Exhibit 8: Palace Theater

Exhibit 8B: Architectural Modifications

Exh. 8B Architectural Modifications to Palace Theater

Exhibit 8C: Seating

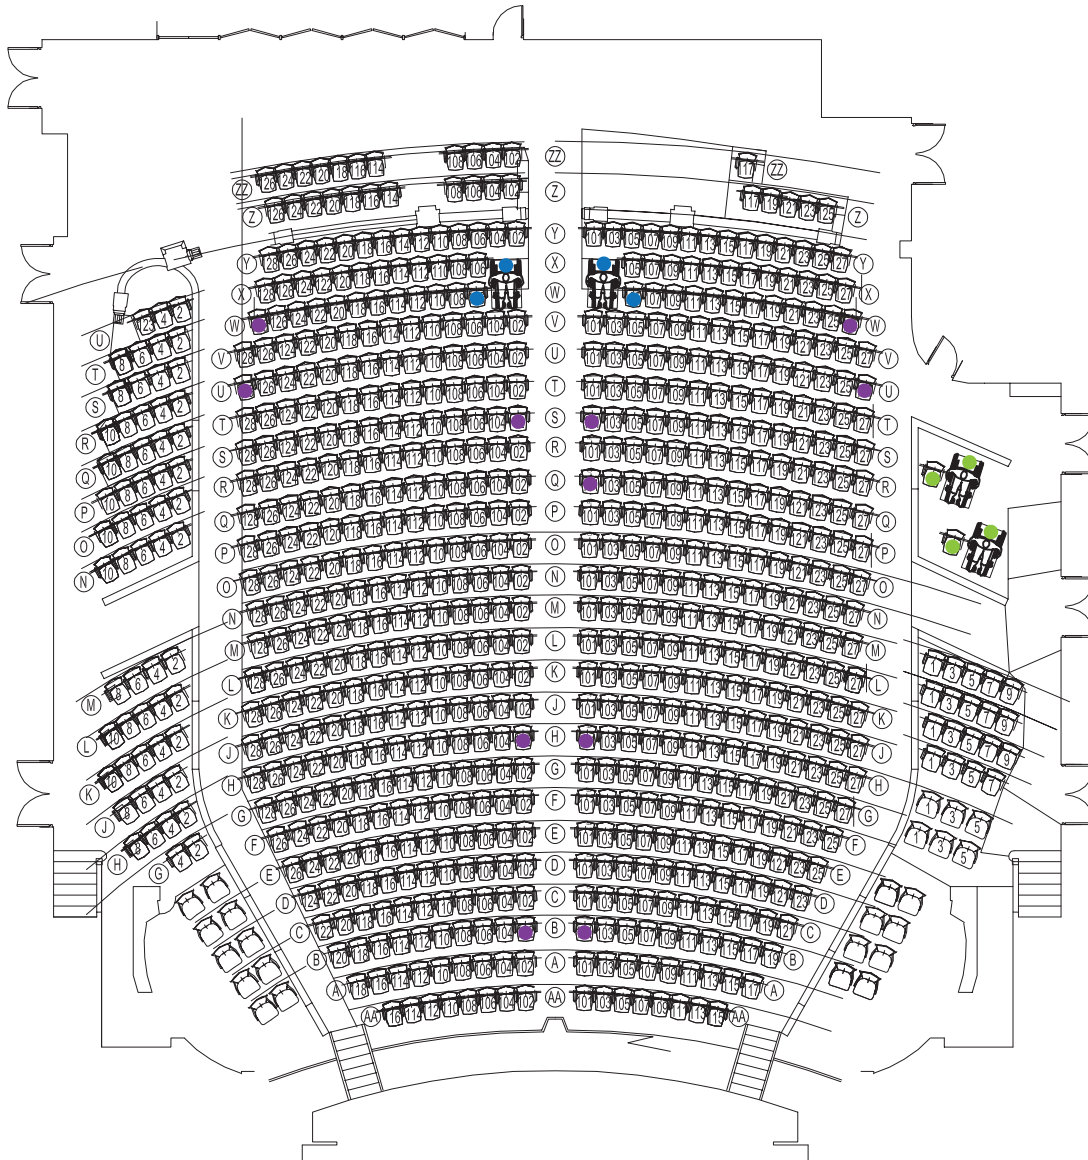
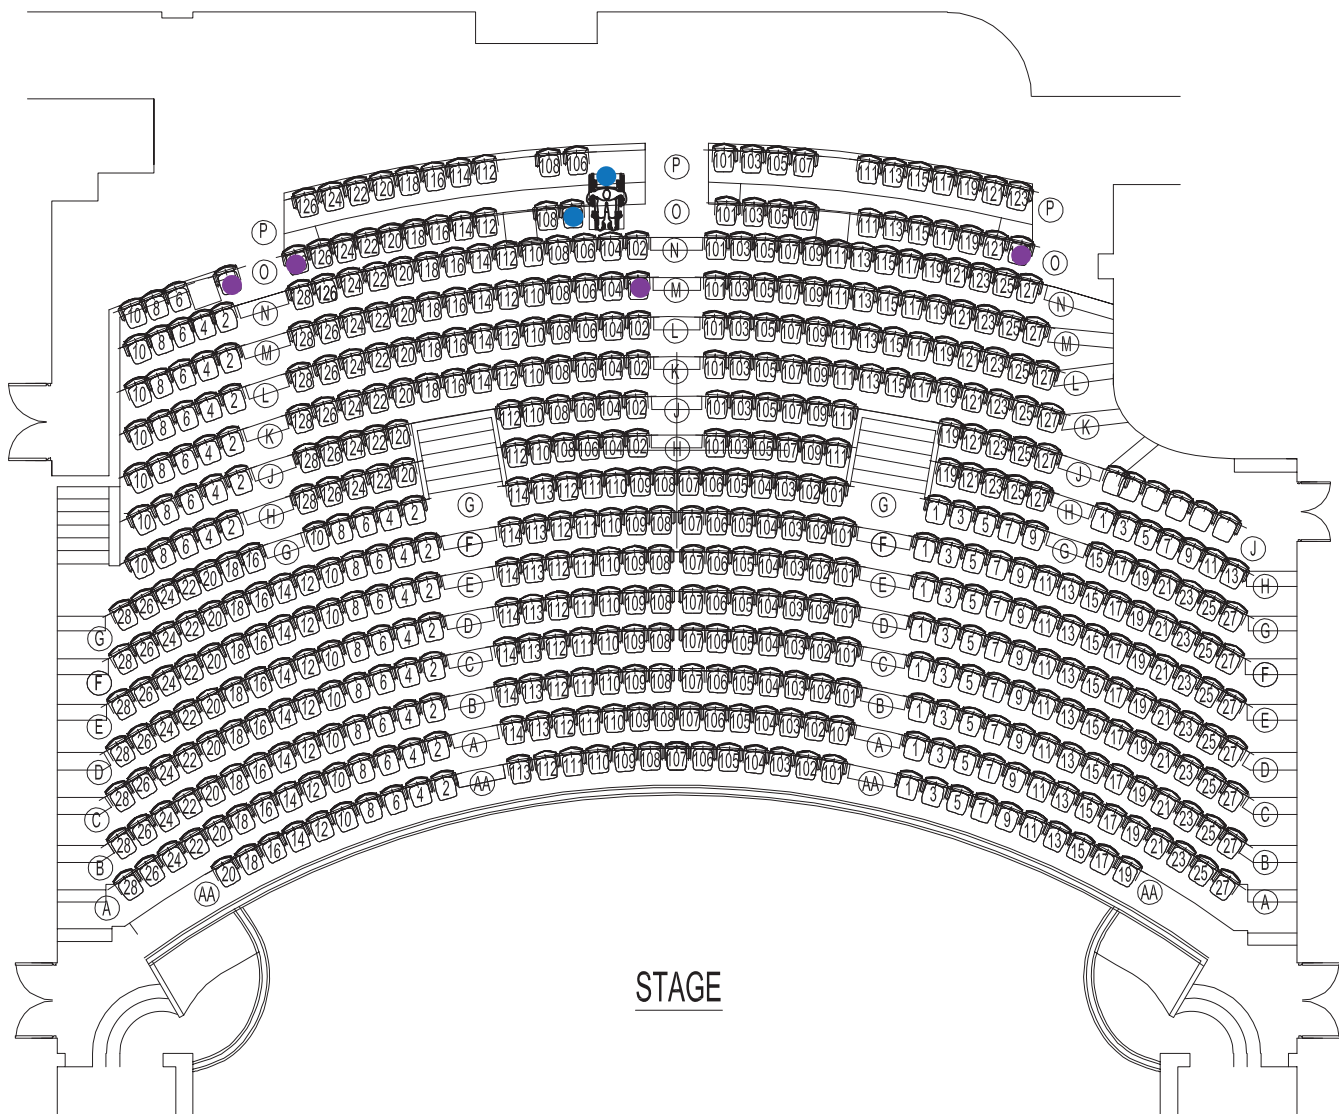
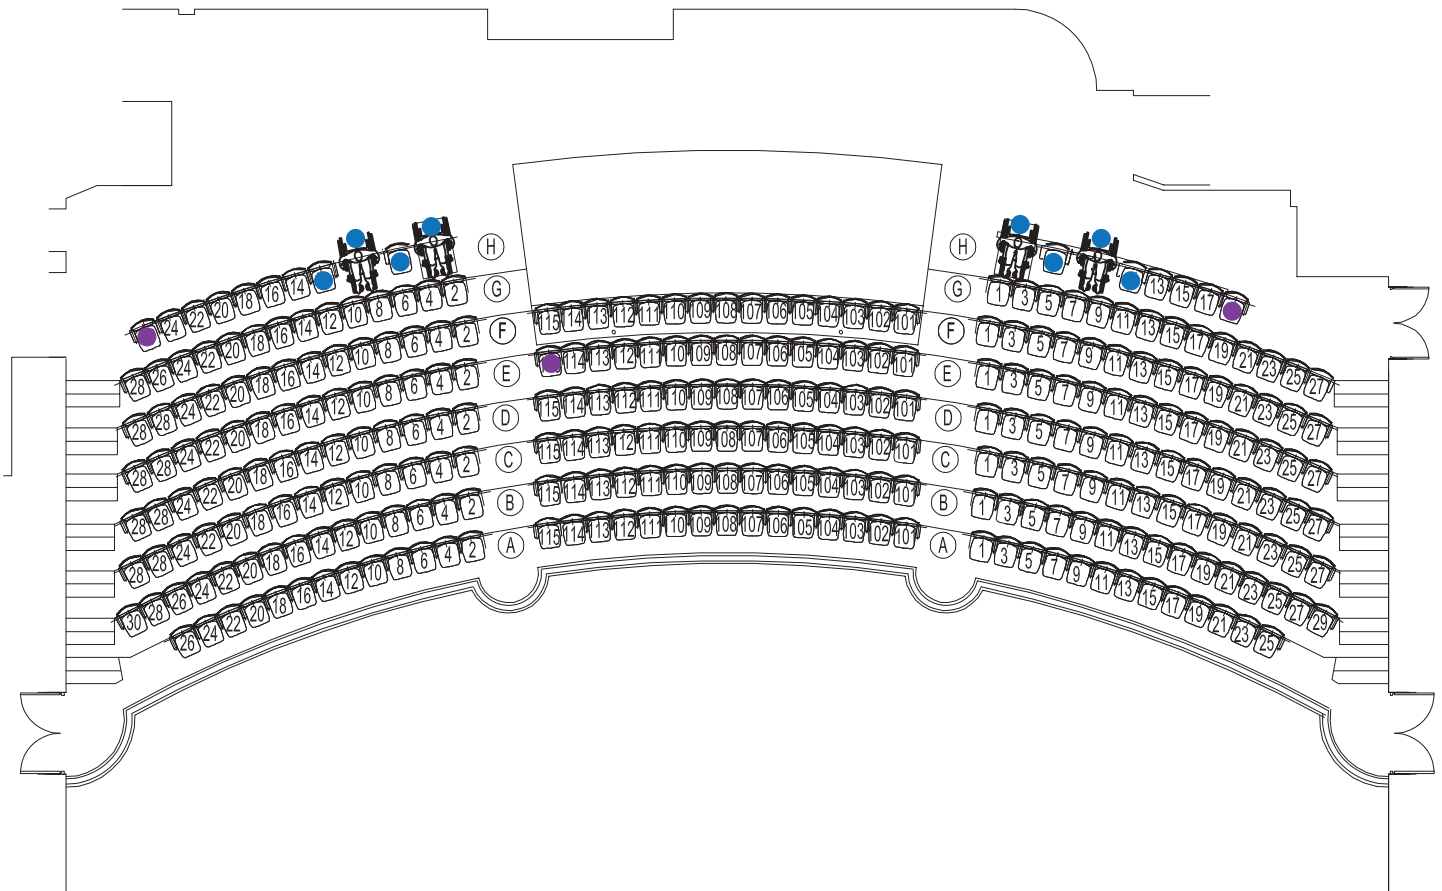
1. Nederlander shall maintain the two existing wheelchair and companion seating locations on the Orchestra level, in the area that would be designated Q1/Q3/Q5/R1/R3/R5, and S1/S3/S5/T1/T3/T5, which includes one companion seating location for each wheelchair seating location. Nederlander shall remove the black metal bars to the left of this area.

2. Nederlander shall add seven new wheelchair seating locations on the Orchestra level at W101/W103/W105/X101/X103 and at W102/W104/W106/X102/X104; on the Mezzanine level at O102/O104/O106/P102/P104; and on the Balcony at H2/H4/H6; at H8/H10/H12; at H1/H3/H5; and at H7/H9/H11; each of which shall include one companion seating location.

3. Nederlander shall add seventeen new aisle transfer seating locations, eleven on the Orchestra level at B101, B102, H101, H102, Q101, S101, S102, U128, U127, W127, W128; four on the Mezzanine level at M102, O2, O123, and O128; and two on the Balcony level at E115 and H19.
